RE: PROPOSED AMENDMENT APPLICATION FOR SSD-58801472

On behalf of the Applicant, Tangaratta Stockfeeds Pty Limited (Tangaratta Stockfeeds) we are writing with respect to SSD-58801472, involving the construction of a new poultry feed mill on land at 771 Wallamore Road, Wallamore, NSW. Specifically, this correspondence is seeking the Department's support for the preparation of an amendment application under Section 37 of the *Environment Planning and Assessment Regulation 2021*.

Figure 3: Amended Site Plan

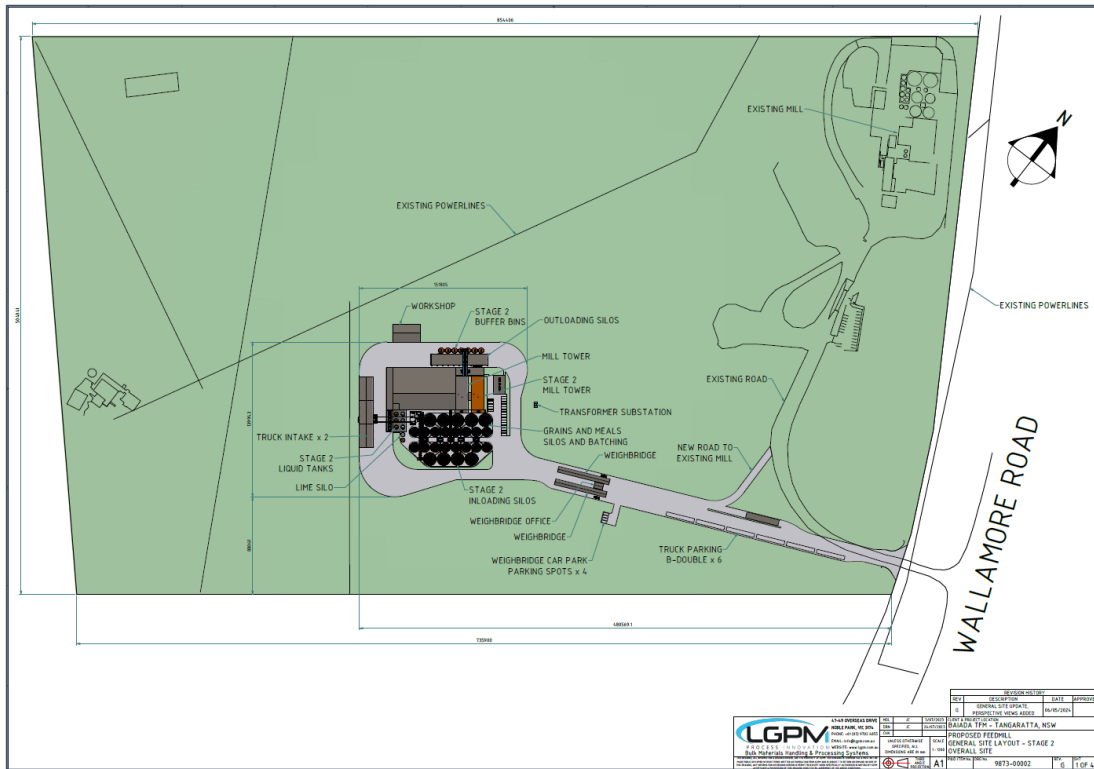
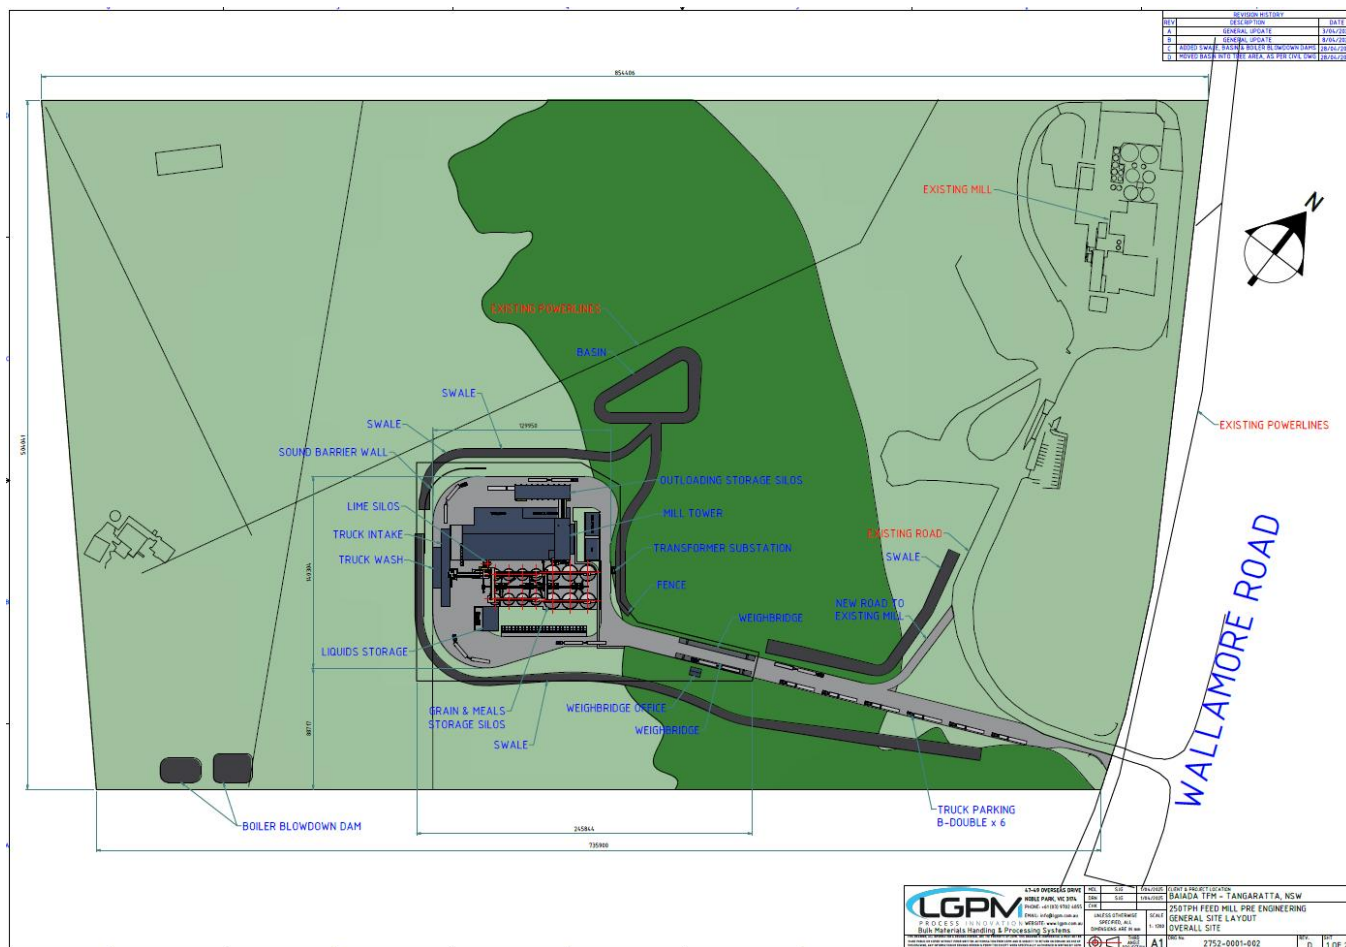
The existing site plan and existing stormwater management plan are shown in *Figure 1* and *Figure 3* respectively. The amended site plan (including the proposed stormwater management infrastructure) is shown in *Figure 3*. As shown, the location of the mill is generally consistent with the current proposal. The boiler blow down dams (a continued use of the existing boiler blow down dams on the site) were not shown on the original site plan but are proposed to be used and were discussed in the original EIS.
